SERVICE BULLETIN

M-1202

Safety Recall Code 0129

2007 DYNA AND SPORTSTER FRONT TIRE RECALL

Figure 1. Tire Size Location on Sidewall

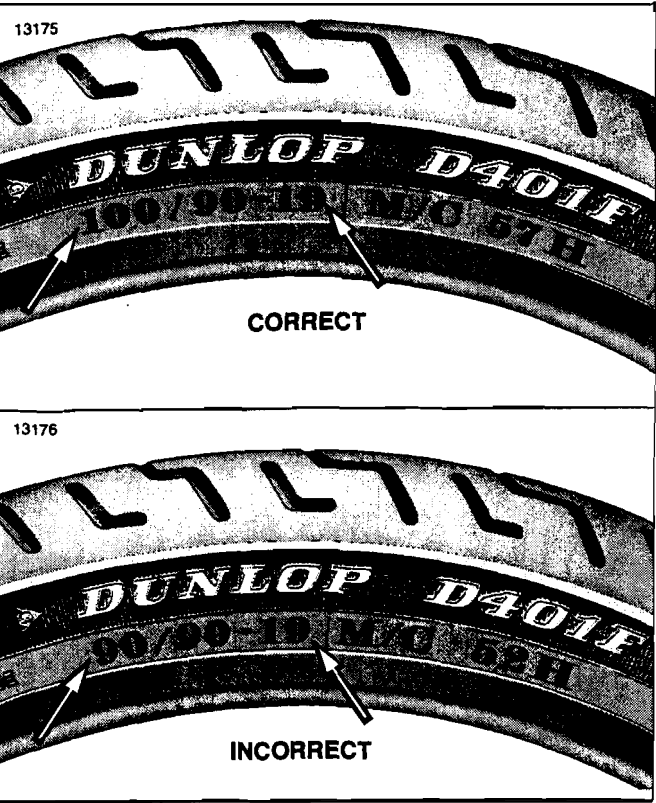
See Figure 1. Inspect and determine if tire on motorcycle is the incorrect tire. The incorrect tire will be tire size 90190-19. The correct tire will be 100/90-19. Replace tire as required. Refer to appropriate model service manual, which contains instructions on performing the required procedure for changing tire.
